SUSQUEHANNA STEAM ELECTRIC STATION, UNIT 1

AMENDMENT TO FACILITY OPERATING LICENSE

Amendment No. 72  
License No. NPF-14

ATTACHMENT TO LICENSE AMENDMENT NO. 72

MAXIMUM AVERAGE PLANAR LINEAR HEAT GENERATION RATE (MAPLHGR) VERSUS AVERAGE PLANAR EXPOSURE  
GE FUEL TYPES 8CR233 (2.33% ENRICHED)  
FIGURE 3.2.1-1

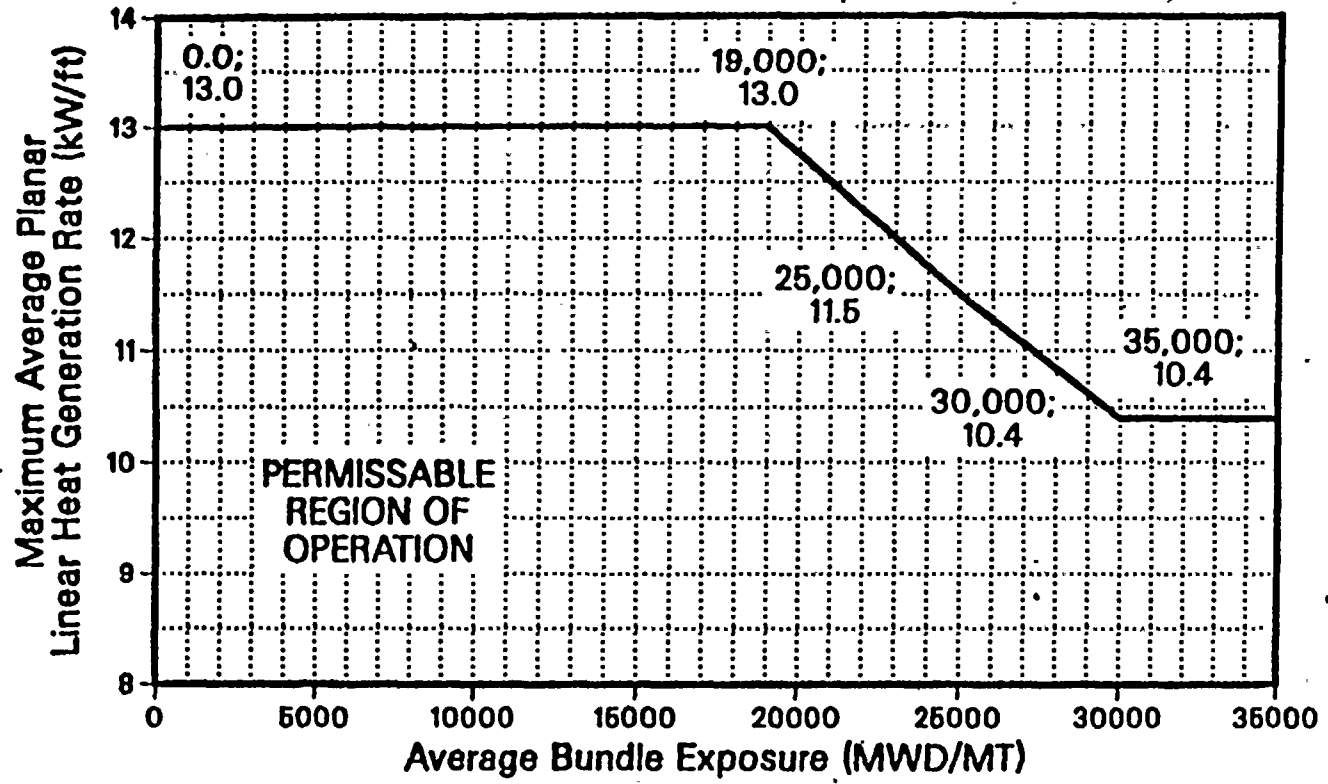
3.2.1 All AVERAGE PLANAR LINEAR HEAT GENERATION RATES (APLHGRs) for each type of fuel as a function of AVERAGE PLANAR EXPOSURE for GE fuel and AVERAGE BUNDLE EXPOSURE for ANF fuel shall not exceed the limits shown in Figures 3.2.1-1, 3.2.1-2, and 3.2.1-3.

With an APLHGR exceeding the limits of Figure 3.2.1-1, 3.2.1-2, or 3.2.1-3 initiate corrective action within 15 minutes and restore APLHGR to within the required limits within 2 hours or reduce THERMAL POWER to less than 25% of RATED THERMAL POWER within the next 4 hours.

FLOW DEPENDENT MCPR OPERATING LIMIT  
FIGURE 3.2.3-1

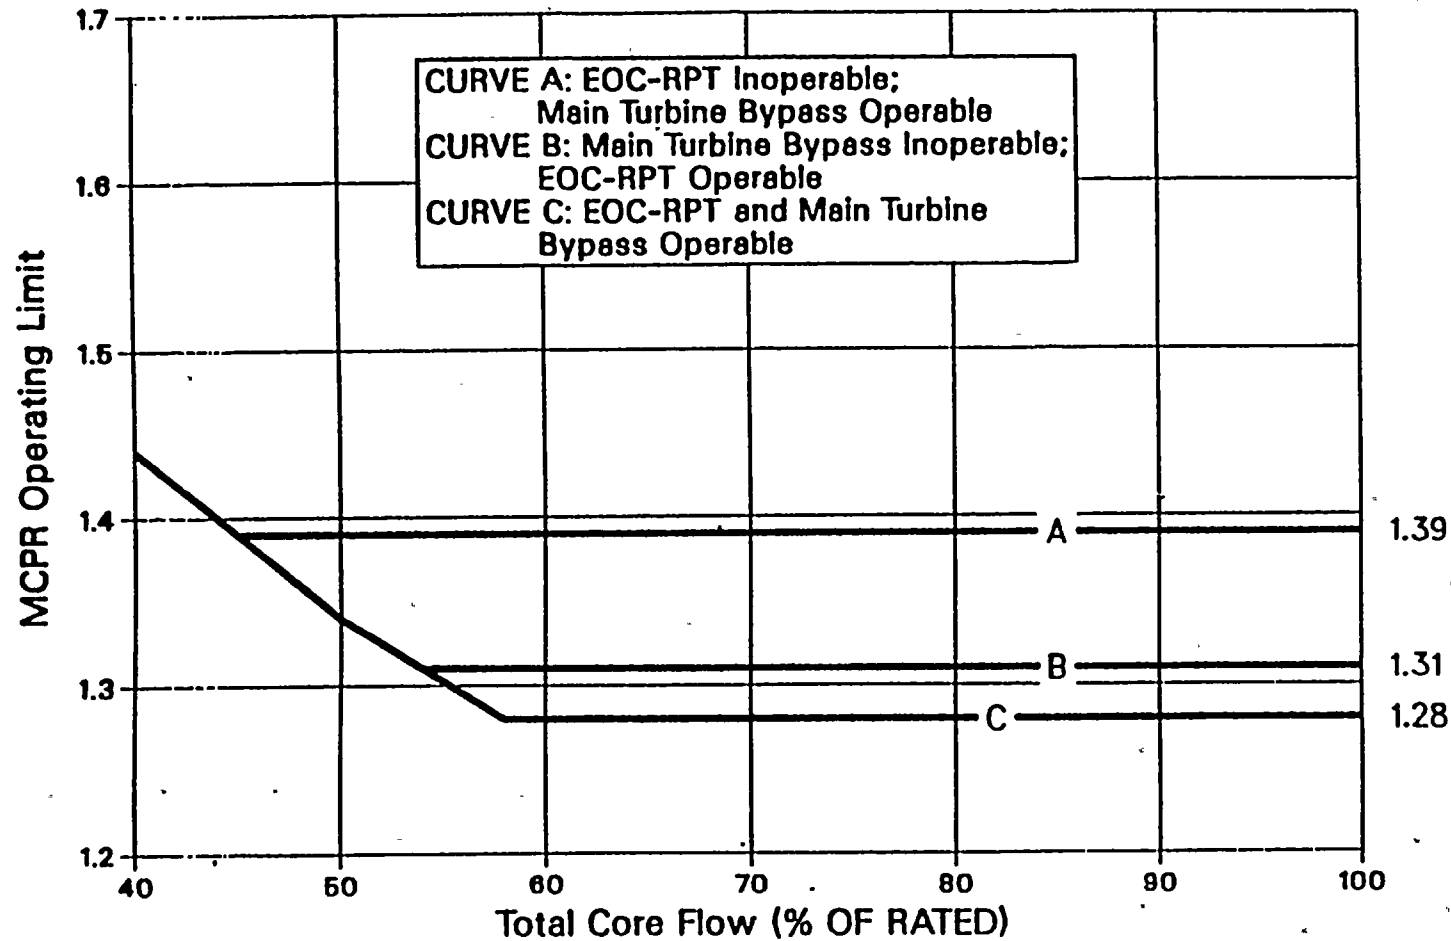
3.2.3 The MINIMUM CRITICAL POWER RATIO (MCPR) shall be greater than or equal to the greater of the two values determined from Figure 3.2.3-1 and Figure 3.2.3-2

Figure 3.2.3-1 defines core flow dependent MCPR operating limits which assure that the Safety Limit MCPR will not be exceeded during a flow increase transient resulting from a motor-generator speed control failure. The flow dependent MCPR is only calculated for the manual flow control mode. Therefore, automatic flow control operation is not permitted. Figure 3.2.3-2 defines the power dependent MCPR operating limit which assures that the Safety Limit MCPR will not be exceeded in the event of a feedwater controller failure initiated from a reduced power condition.

Figure 3.2.3-2

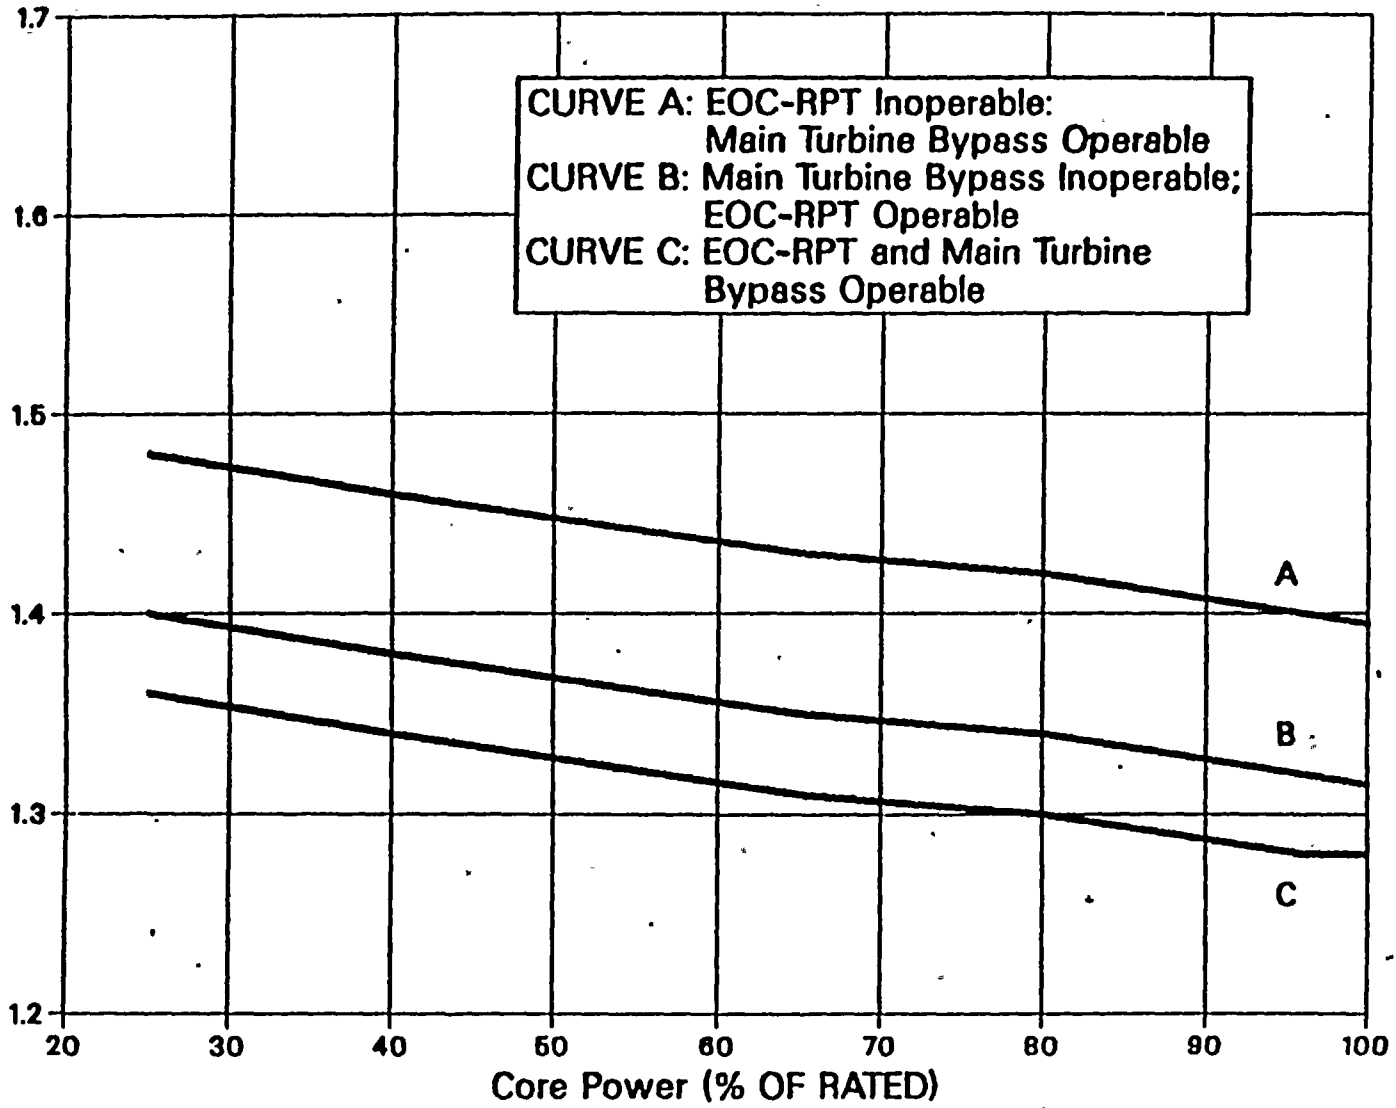
To assure that the fuel cladding integrity Safety Limit is not exceeded during any anticipated abnormal operational transient, the most limiting transients have been analyzed to determine which result in the largest reduction in CRITICAL POWER RATIO (CPR). The type of transients evaluated were loss of flow, increase in pressure and power, positive reactivity insertion, and coolant temperature decrease. The limiting transient yields the largest delta MCPR. When added to the Safety Limit MCPR, the required minimum operating limit MCPR of Specification 3.2.3 is obtained and presented in Figures 3.2.3-1 and 3.2.3-2.

**LINEAR HEAT GENERATION RATE (LHGR) LIMIT  
VERSUS AVERAGE PLANAR EXPOSURE  
ANF 8X8 FUEL  
FIGURE 3.2.4.2-1**

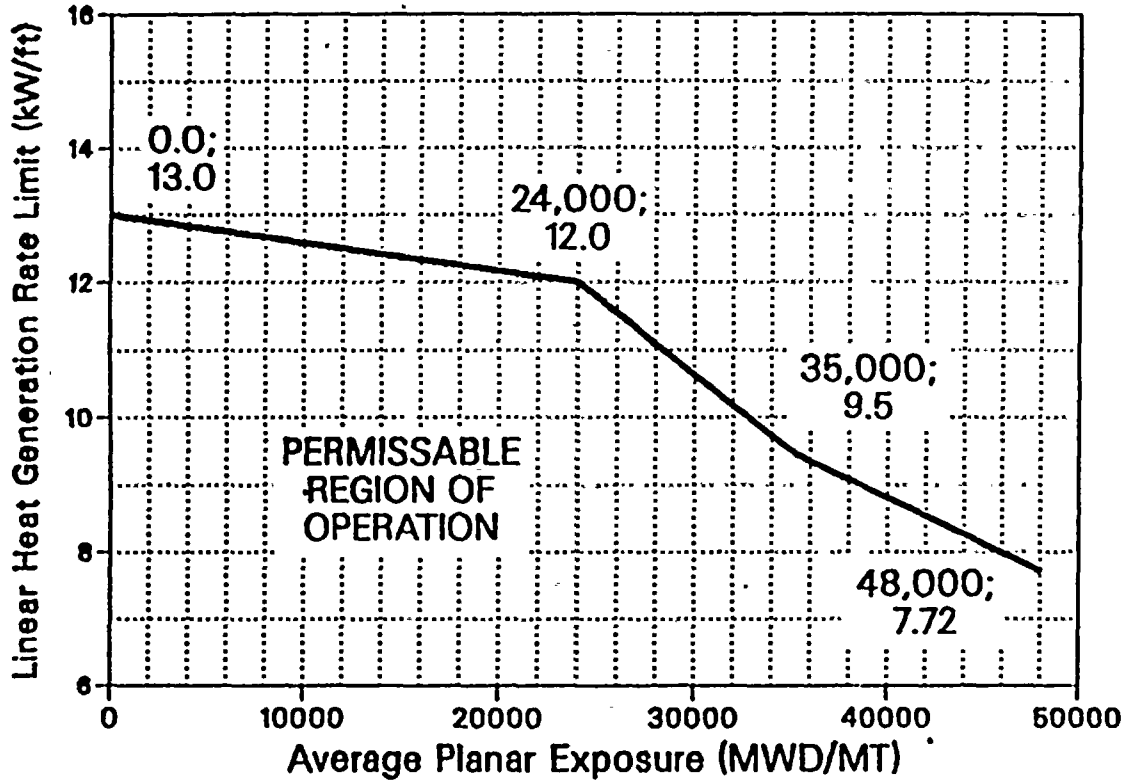
3.2.4.2 The LINEAR HEAT GENERATION RATE (LHGR) for ANF fuel shall not exceed the LHGR limit determined from Figures 3.2.4.2-1 and 3.2.4.2-2.

With the LHGR of any fuel rod exceeding its applicable limit from Figure 3.2.4.2-1 or 3.2.4.2-2, initiate corrective action within 15 minutes and restore the LHGR to within the limit within 2 hours or reduce THERMAL POWER to less than 25% of RATED THERMAL POWER within the next 4 hours.

Figure 3.4.1.1.1-1  
THERMAL POWER LIMITATIONS

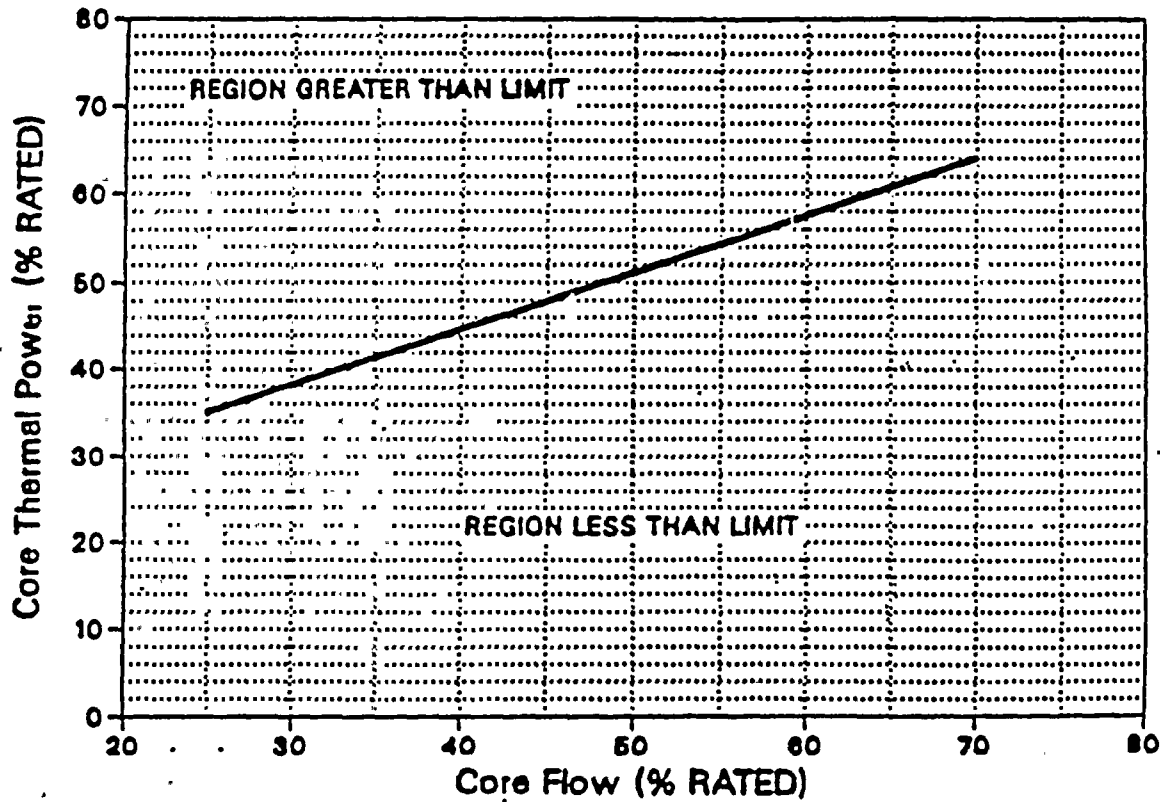
- b. APRM and LPRM\*\*\* neutron flux noise levels shall be less than three times their established baseline levels when THERMAL POWER is greater than the limit specified in Figure 3/4.1.1.1-1.
- c. Total core flow shall be greater than or equal to 42 million lbs/hr when THERMAL POWER is greater than the limit specified in Figure 3.4.1.1.1-1.
